**MODELS AFFECTED:** 407

**SUBJECT:** CARGO HOOK KIT 206-706-341-109/-111, MANUAL AND ELECTRICAL RELEASE SYSTEMS, MODIFICATION OF.

**HELICOPTERS AFFECTED:** 407, Serial Numbers 53000 through 53152 and 53154 through 53165.

**DESCRIPTION:** This bulletin changes the position of the manual cargo release mechanism to give clearance between the cargo release handle and the copilot seat bottom cushion. This bulletin also changes the wires of the electrical release system. This will increase the amperage rating of the circuit breaker.

Figure 1. Installation of new support (407-070-921-103) (Sheet 1 of 5)

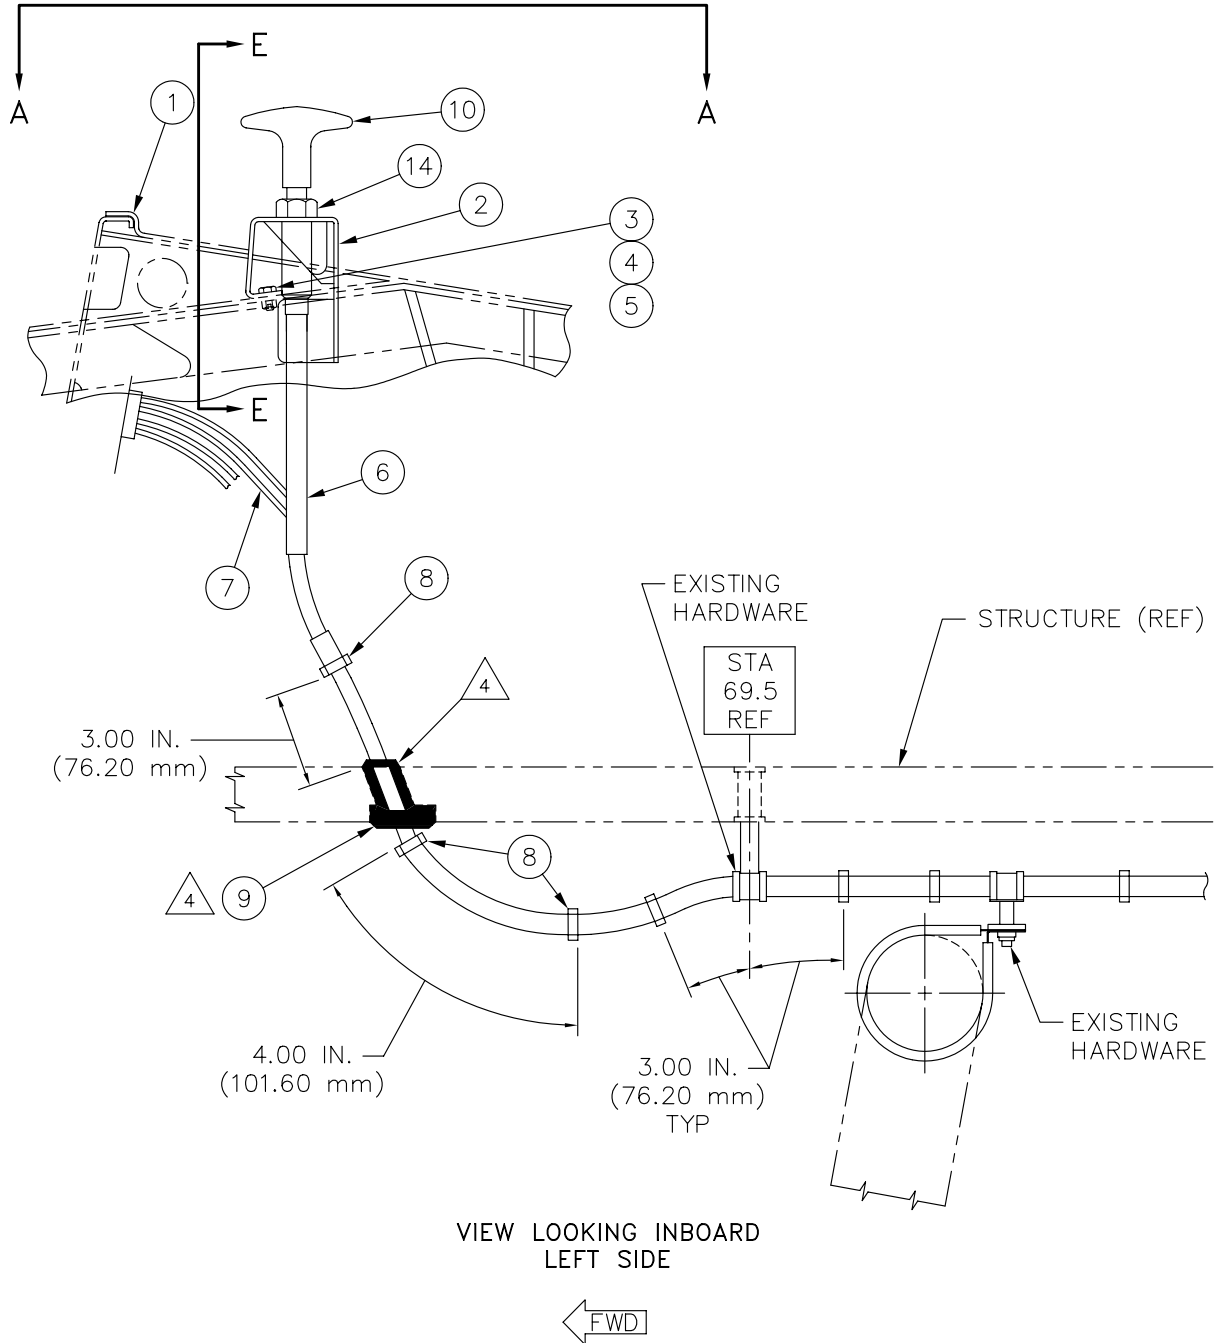
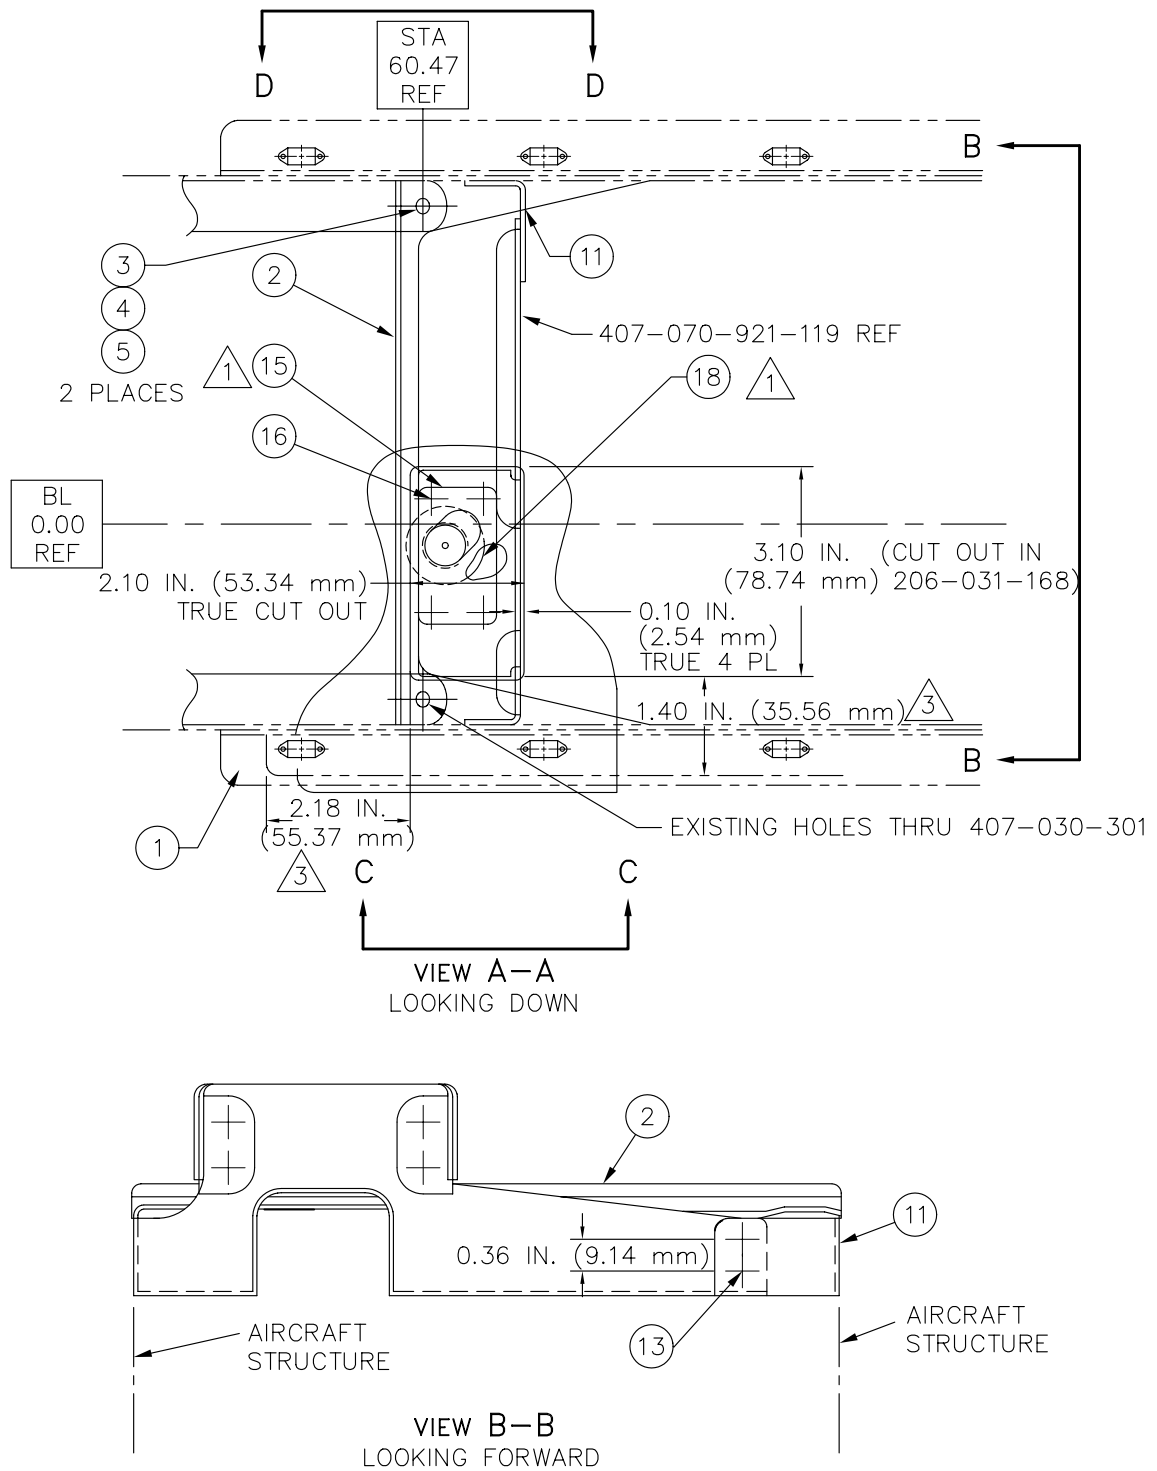
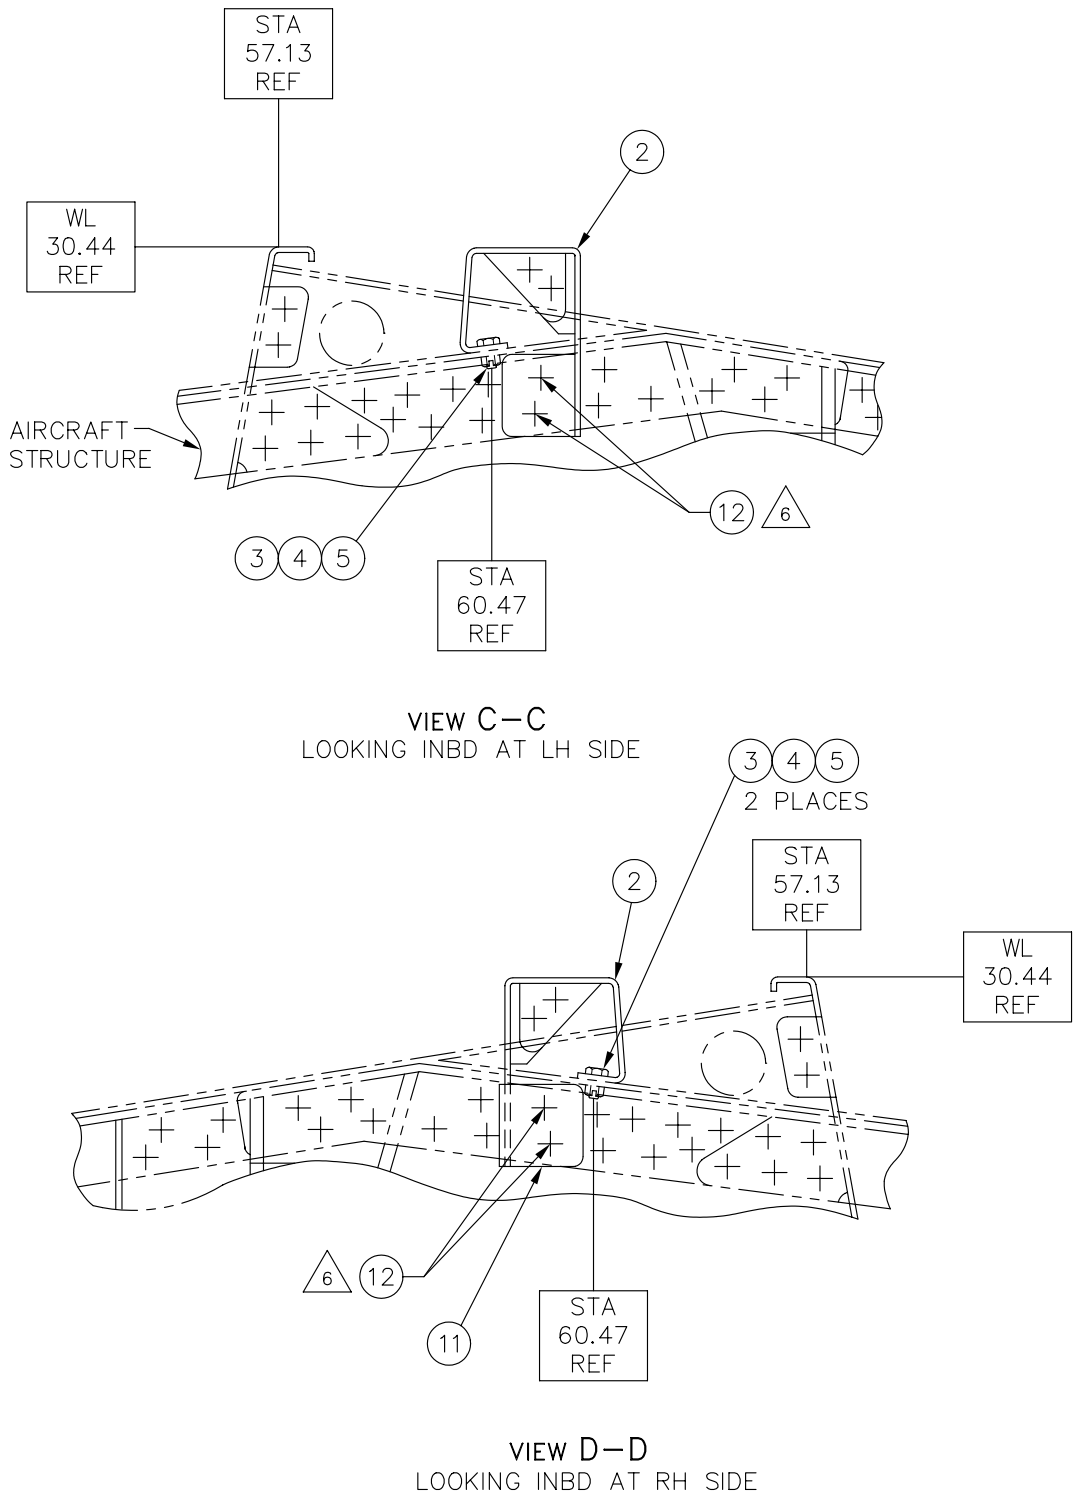
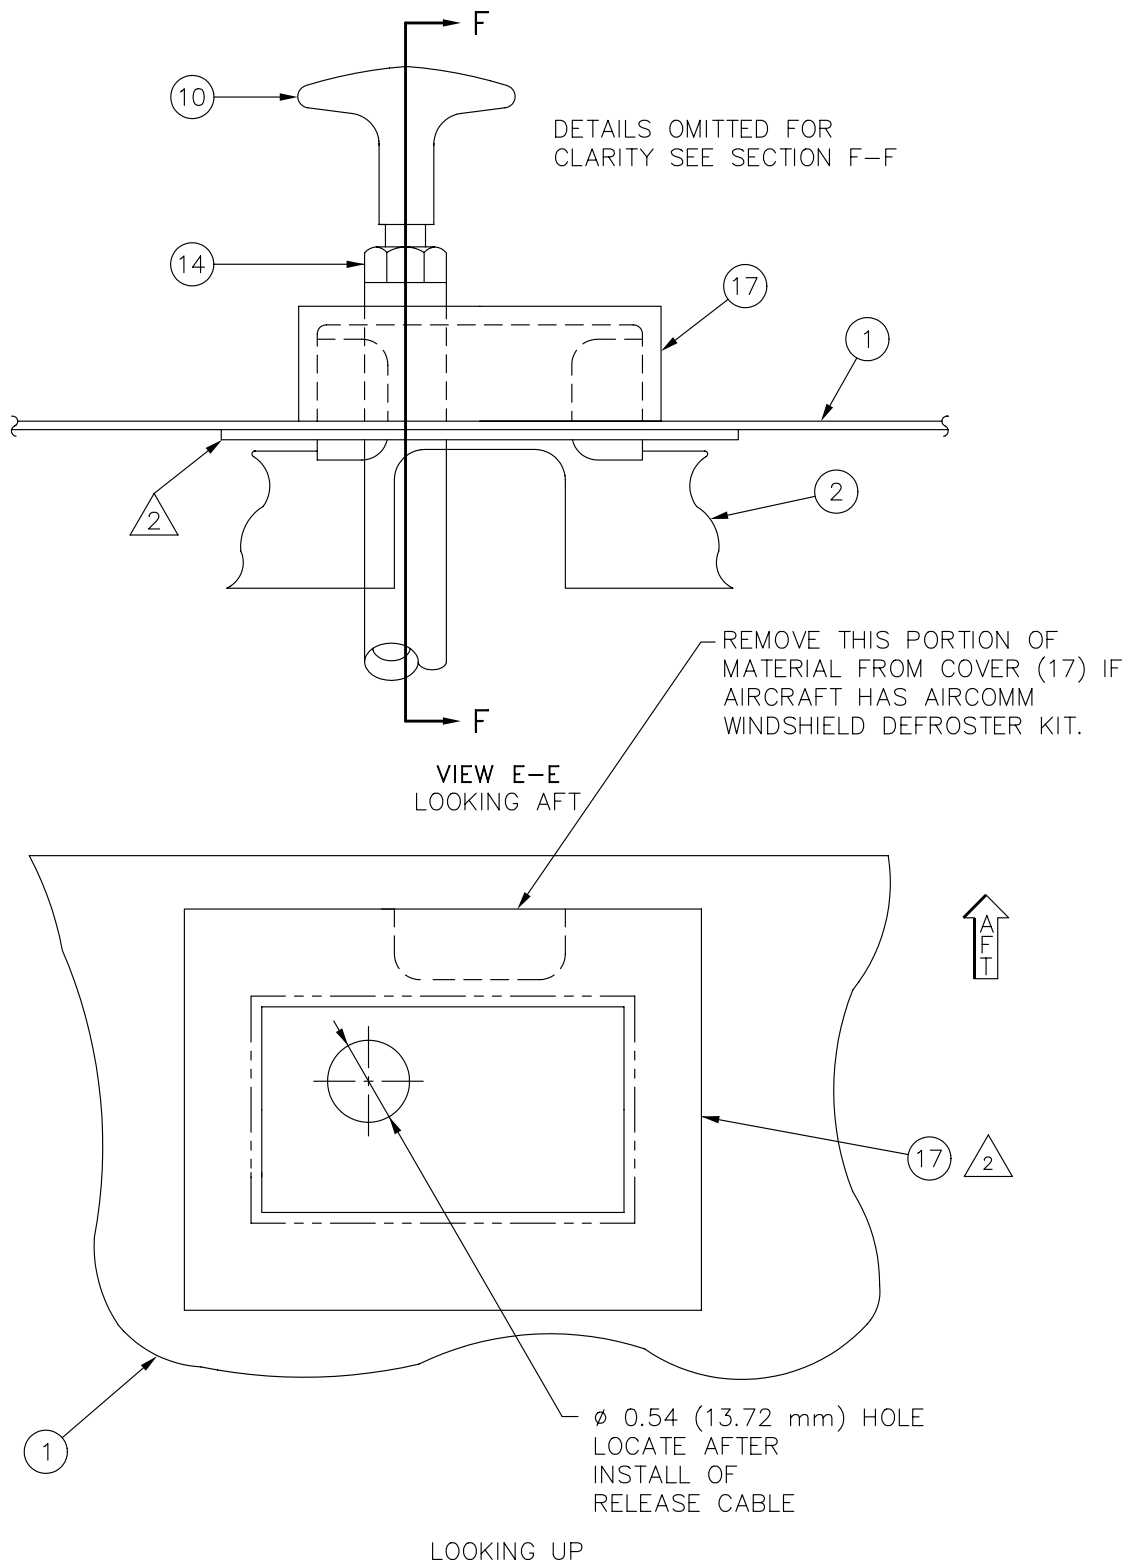
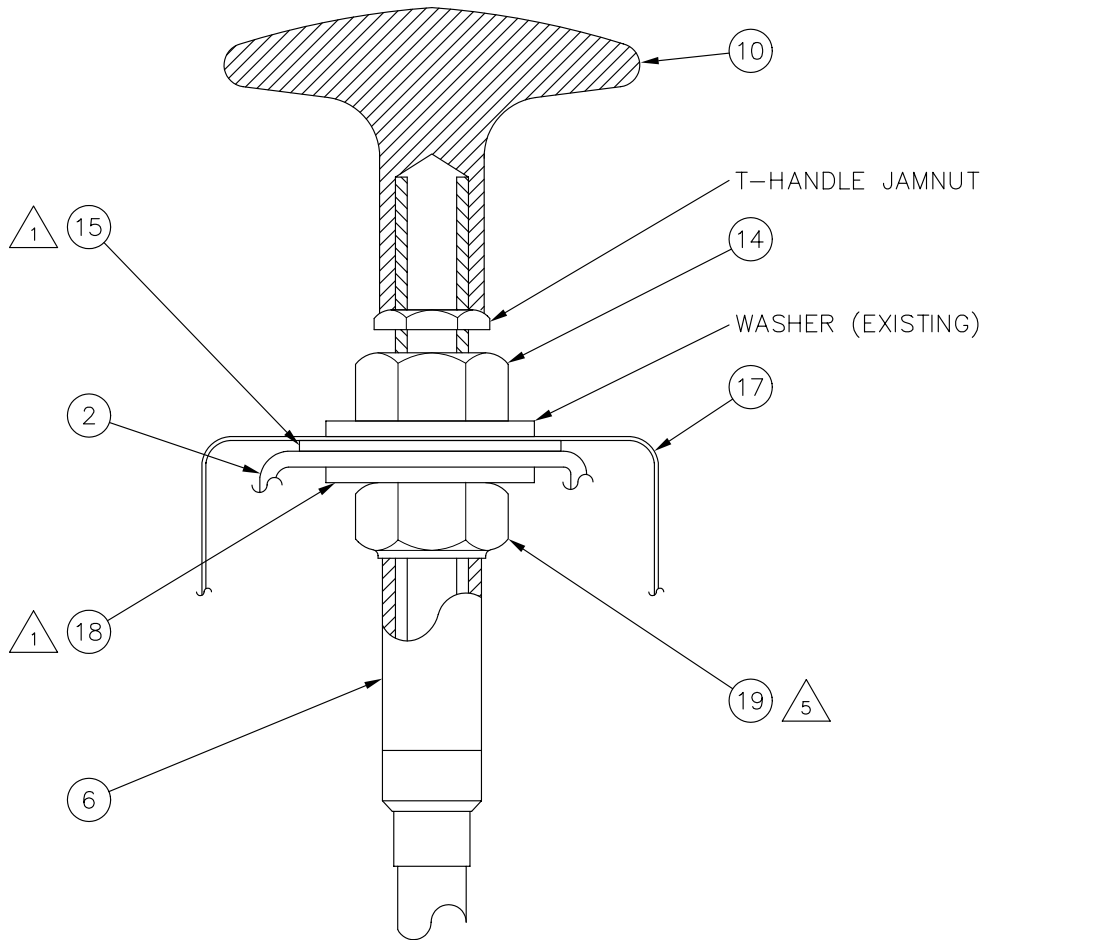
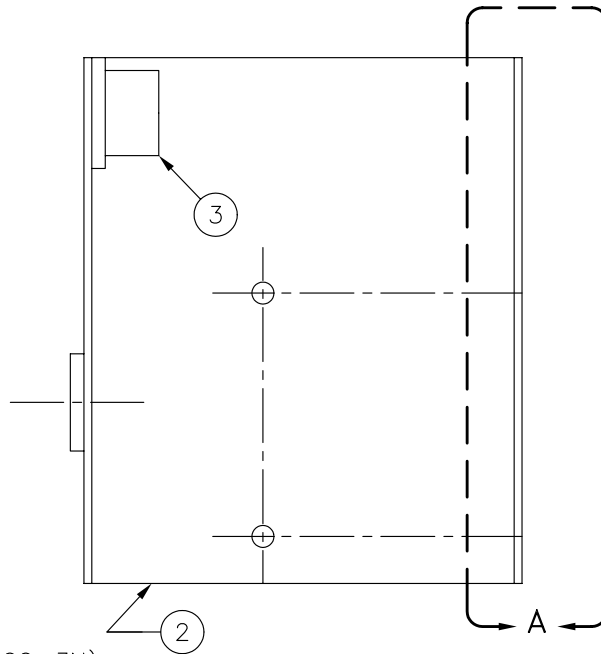
Part I of this bulletin gives the procedures to change the manual cargo release system.

- B. INSTALLATION OF THE NEW SUPPORT.
8. Remove the two rivets on each side of the aircraft structure (Figure 1, Views C-C and D-D).
  9. Put the new support (2) in position on the bolt holes that are in the aircraft structure (F.S. 60.47). Attach the forward legs of the support (2) with the hardware (3), (4) and (5) that you kept in step 7.

10. Use the holes in the left hand side of the aircraft structure as a template to back drill the support (2, Figure 1, View C-C). Use a #30 drill. Install clecos through the holes in the support and the airframe structure.

11. Put the clip (11) in position against the right hand aft side of the support (2) and against the airframe structure (refer to View D-D). Attach the clip (11) to the support (2) with a clamp.

12. Use the holes in the right hand side of the aircraft structure as a template to back drill the clip (11). Install clecos through the holes in the clip and the airframe structure.

13. Use a #30 drill to make two holes through the clip (11) and the support (2, Figure 1, View B-B).
  14. Remove the support (2) and the clip (11) from the helicopter.

23. Install the doubler (15) on the top of the oblong hole in the support (2). Align the hole in the doubler (15) with the index marks done in step 22.

24. Drill four holes in the doubler (15) and the support (2) with a #40 drill (Figure 1, View A-A). Make sure you have the correct edge distance. Remove the doubler from the support and deburr all the holes. Cut the edges of the doubler (15) that are not in contact with the support (2).

28. Calculate the location of the hole in the new cover (1) for the support (2, Figure 1, View A-A). Cut the hole in the cover. Install the cover on the pedestal to make sure it fits. Make sure that a gap of 0.010 inch (2.6 mm) is between the cover (1) and the support (2).

31. Make a 0.54 inch (13.7 mm) hole in the vinyl fabric cover (17) that aligns with the hole in the doubler (15).
32. Install the release cable (6), use the hardware stack up shown in Figure 1 Section F-F. Do a functional check of the manual release system (BHT-407-II-5, Section 1-6) and make sure that the release cable operates smoothly.

Figure 2. Modification of support (206-072-938-001)

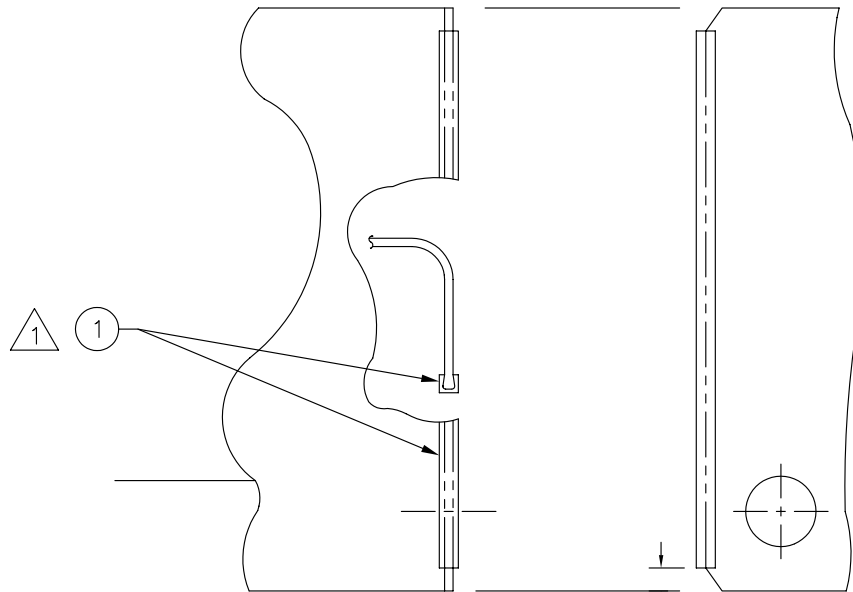
D. MODIFICATION OF SUPPORT 206-072-938-001.

33. Install the correct length of the caterpillar type grommet (1, Figure 2) to the aft flange of the support (2) with adhesive (C-301).

Figure 3. Modification of electrical wiring (Sheet 1 of 2)

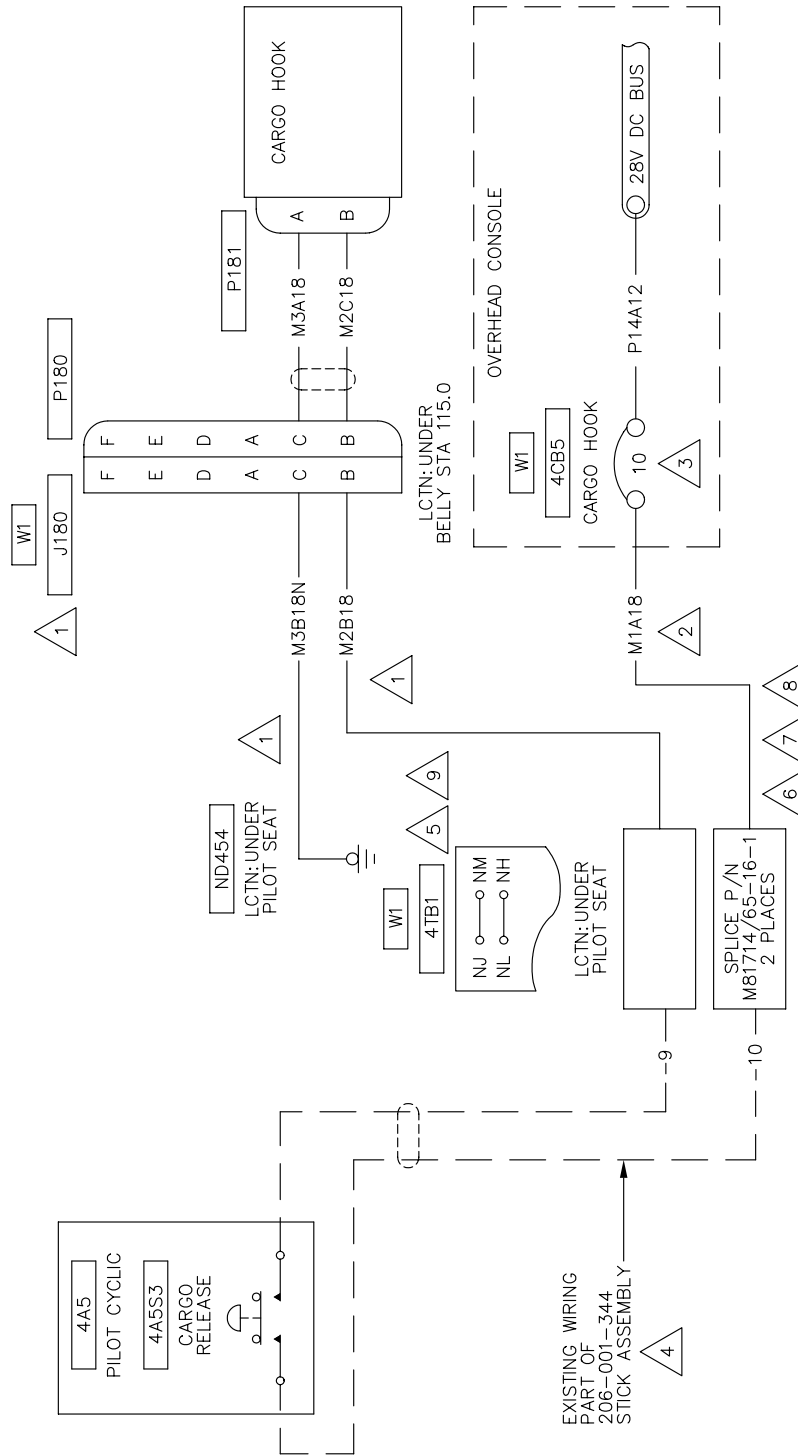
Part II of this bulletin gives the procedures to change the electrical release system.

**Part II - MODIFICATION OF ELECTRICAL WIRING.**

- △<sub>1</sub> Replace as a unit, the cable assembly made up of the connector (J180) and wires M3B20N and M2B20, with the new cable assembly that includes the new connector (J180) and the new wires M3B18N and M2B18.

- △<sub>2</sub> Replace the wire M1A20 with the new wire M1A18.
- △<sub>3</sub> Replace the circuit breaker MS26574-5 with the new circuit breaker MS26574-10.

- △<sub>4</sub> Replace the wires -9 and -10 (gauge 20) in the cyclic stick grip assembly with the new wires -9 and -10 (gauge 18).
- △<sub>5</sub> Use insertion/removal tool M81969/16-02 for TB 4TB1.

- △<sub>6</sub> Use insertion/removal tool M81969/14-03 for the splice.
- △<sub>7</sub> Connect the wire -9 to the wire M2B18 and the wire -10 to wire M1A18 with splices P/N M81714/65-16-1. Use pins M39029/22-193 included with the splice. Make a loop with the wires near the terminal block (4TB1) and safety them to the harness.

- △<sub>8</sub> Use the correct crimp tool/positioner. Refer to Special Tools section of this bulletin.
- △<sub>9</sub> Use seal plugs P/N MS27488-20 to seal open contacts NH, NJ, NL and NM of 4TB1.
